## **ATTACHMENT A – S.96 MODIFICATION PLANNING REPORT**

The S.96 Modification is in relation to the Stage 1B Mountain Bike Trails, DA 6751. The proposed modification relates to seeking a minor variation to approved Trail 13 (All Mountain Trail) between the Antons Access Road and the top of the Gunbarrel Chairlift.

**RE: Trail Alignment Inspection – DA 6751 Stage 1B MTB - Thredbo Alpine Resort**

Figure 1: Trail 13

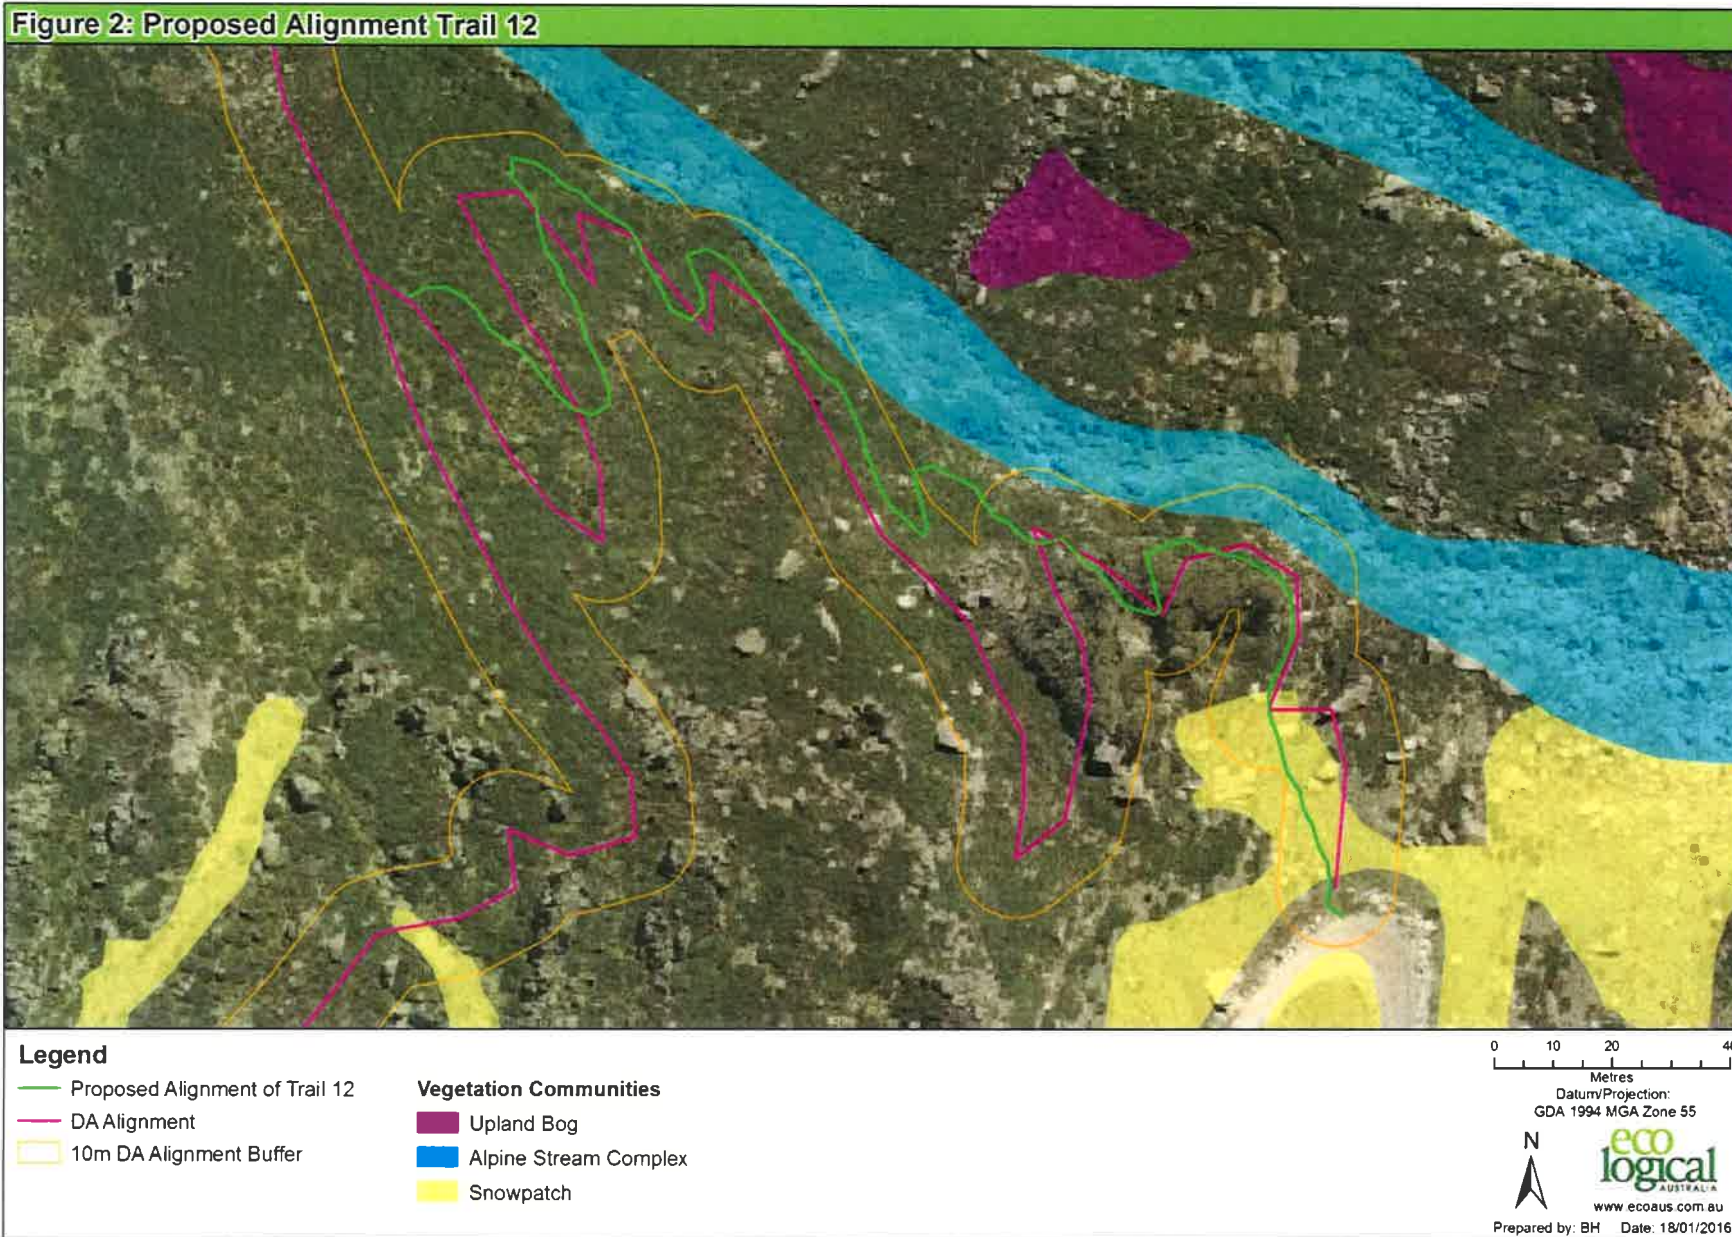
I confirm that the proposed alignment is generally consistent with the development consent. However, the proposed alignment of the lower part of Trail 13 deviates from the alignment proposed in the development application (the DA Alignment), as identified in in **Figure 1**. These alignment changes have been proposed by DirtArt to assist construction, minimise potential impacts on the environment, and improve rider experience. Most of the changes to the alignment are within 10 m of the alignment as marked by World Trail (see **Figure 1**). Where the proposed alignment is beyond the 10 m buffer to the DA alignment, the proposed alignment is consistent with the development consent as it affects the same vegetation communities and fauna habitats, however it substantially reduces the impacts associated with this part of Trail 13 as it:

- Reduces the trail length by approximately 400 m and thus the trail footprint and associated disturbance by an estimated 680 m<sup>2</sup>.
- Substantially reduces the amount of *Ranunculus anemoneus* plants affected.
- Enables a more gradual loss of elevation along the trail alignment thus reducing the occurrence of short steep sections of trail and thus the potential for erosion and subsequent impacts.
- Reduces the amount of rocks and trees that will be removed and / or otherwise disturbed and thus reduces impacts on fauna habitats.

The location of proposed bridge and platform are shown in **Figure 1**. The proposed bridge spans the only area of Upland Bog traversed by the proposed trail alignment, as shown in **Figure 1**. One small platform is proposed to traverse a minor watercourse as shown in Photo 1.

I confirm that the potential impacts associated with the proposed alignment are improvements to the proposal which reduce the potential impacts associated with the trail. The proposed alignment will not result in any adverse impacts that have not been assessed as part of the development assessment or post approval inspection process.
